DESIGN REVIEW BOARD

REVISED MEETING MINUTES

Review Memorandum: Asa Parlin House Addition - 17 Woodbury Lane
February 29, 2024

Document Reviewed: A concept drawing entitled Asa Parlin House Rehabilitation, dated 2/13/2024, prepared by Bergman Hendrie + Archetype, architect for the project.

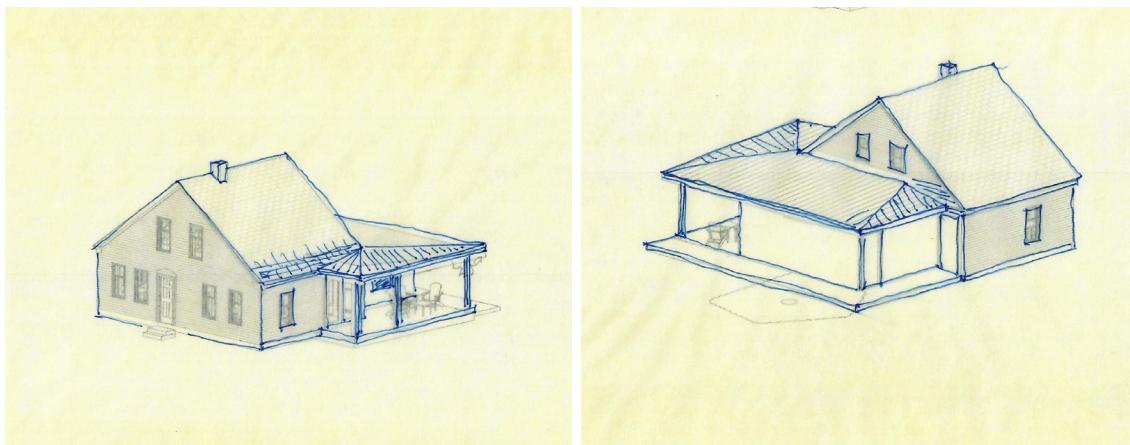
The three dimensional concept for the proposed addition, inclusive of the wrap around porch, is a relatively simple one story shed roofed structure that will be partially visible from Woodbury Lane.

- DRB members are comfortable with the updated programming decisions made and with the general design direction of the addition.
- The low slung shed roof structure as proposed is an appropriate choice for the overall massing of the addition as it is deferential to the existing house. DRB members are in agreement with the intent for the addition to be clearly differentiated from the original house architecture. However, DRB members are not comfortable with the awkward relationship that develops as the shed roof intersects with the the original house and its gable roof. The DRB propose that the shed roof be reshaped to a modified hip that will align the addition's roof edge with the existing gable roof as shown in the following sketch images.

- The suggestion of a standing seam metal roofing system is a good choice. It is recommended that a waterproof membrane be installed below the metal roof. DRB members prefer that the addition exterior materials be distinct from the existing house finishes.

- The DRB recommends that the choice for exterior siding of the addition be smooth vertical tongue and groove boards to distinctly contrast with the traditional horizontal siding of the house.

- The DRB would prefer the window from the kitchen space be shifted to the south facing side of the porch, where it will be less of an obvious visual, yet offer an opportunity for serving of ice cream and other treats during events that likely will be take advantage of the available green space.

- The suggestion of simple 4x4 posts to support the roof at the porch appears appropriate.
- The DRB requests the project proposal return for a further review by the board after the addition is more fully developed and with the landscape concept for the adjacent southern green area
